Re: Green Mountain II

POADP # 654

GREEN MOUNTAIN SUBDIVISION
 PRELIMINARY OVERALL DEVELOPMENT PLAN
 SAN ANTONIO • BEXAR COUNTY • TEXAS

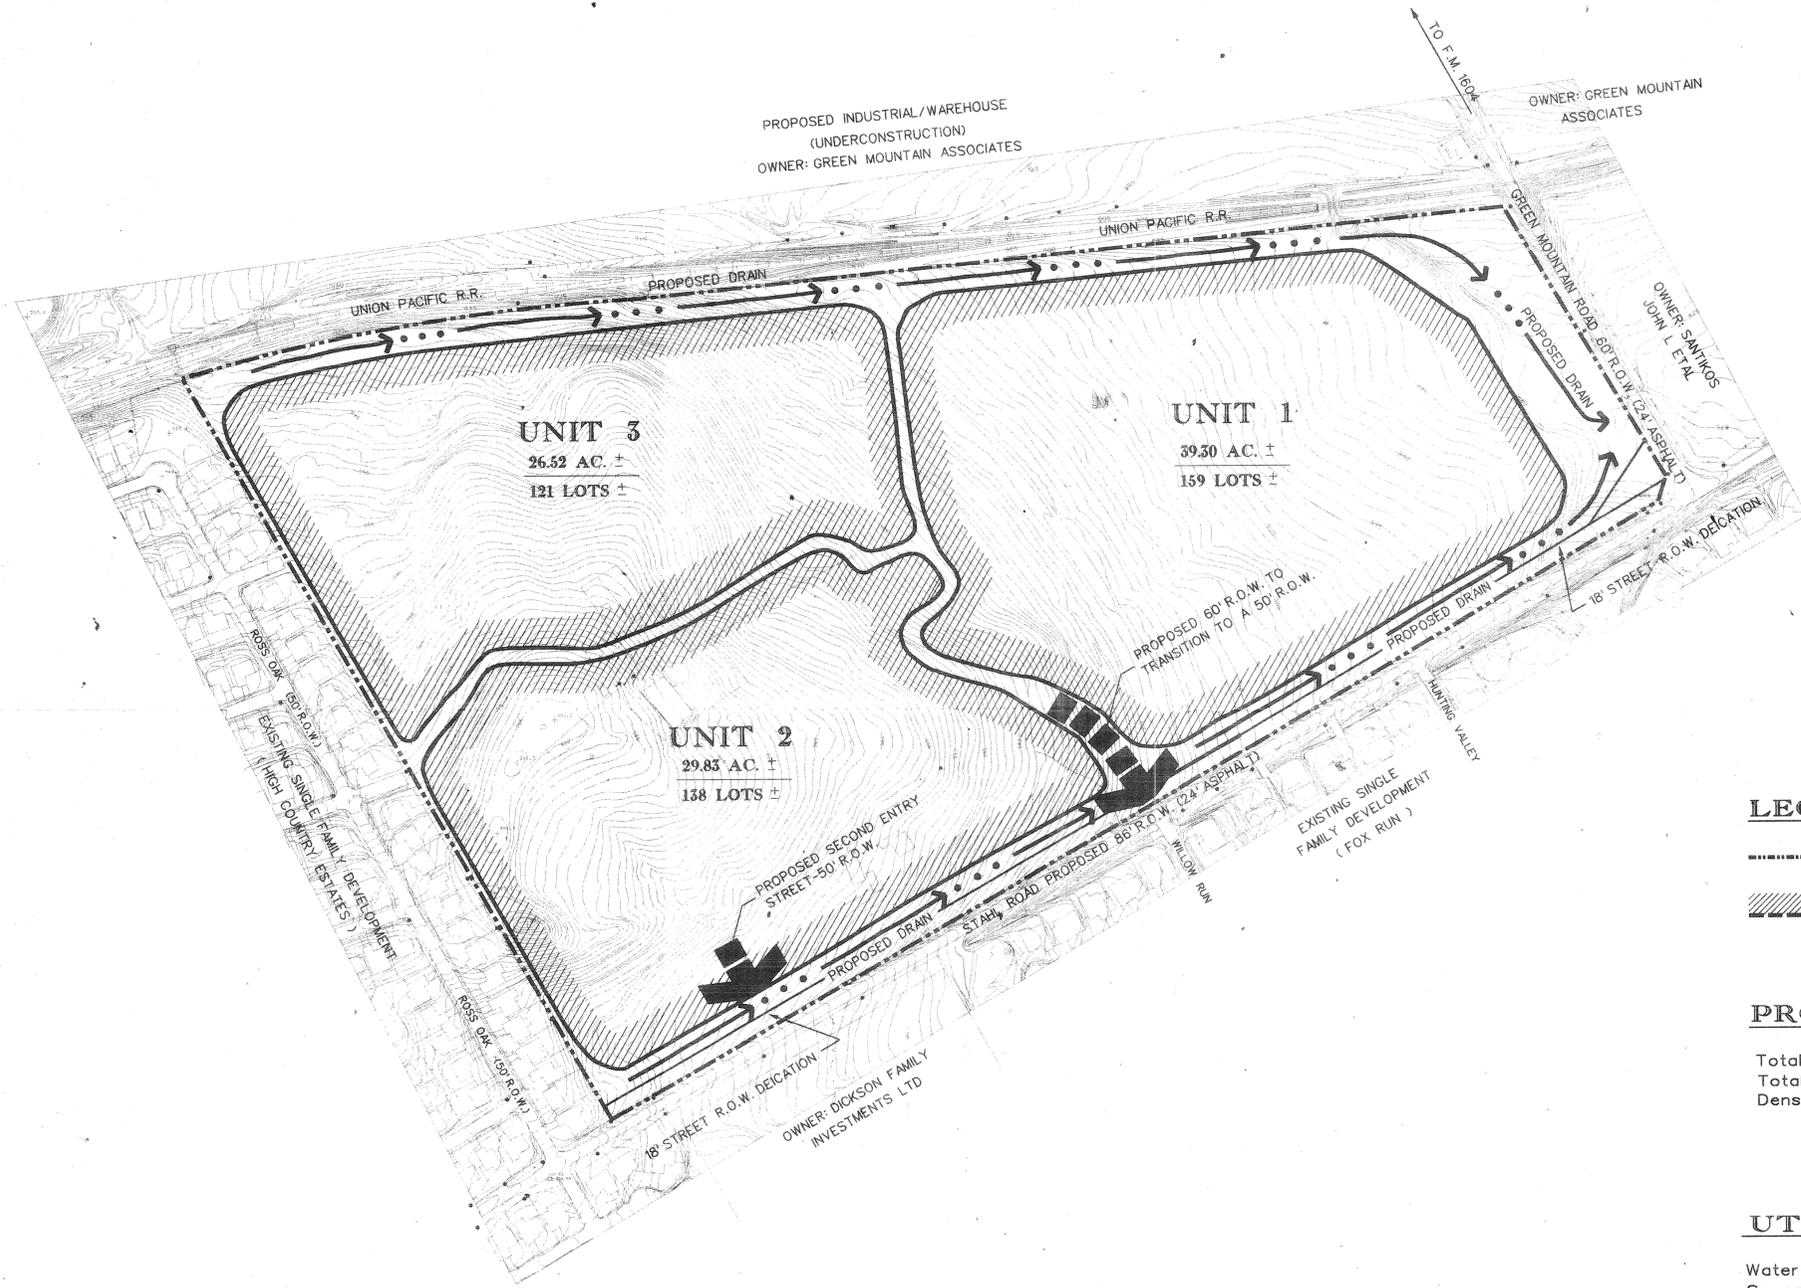
- Based on the topography, a Flood Plain Study and drainage review will probably be required during the platting process including detention requirements.

- In consideration of public safety and convenience, excessive grades by reason of topography should be avoided in street layouts and arrangements.
- Access and R.O.W. issues along State facilities will need to be resolved with the Texas Department of Transportation (TXDOT). For information about these requirements you can contact TXDOT at 615-5814.

- This development will need to comply with tree preservation ordinance #85262. For information about these requirements you can contact Building Inspections at 207-7102.

- It will be expected that you will plat all of the property depicted in your POADP, to include: floodpains, drainage areas and open space.
- I would encourage you to work closely with the school district, so that they can plan accordingly.

- Green Mountain Rd. is designated as a secondary arterial, Type A, and requires 86' of right-of-way.
- Connections will need to be continued at Bramble Tree and Oak Run (High Country Estates).
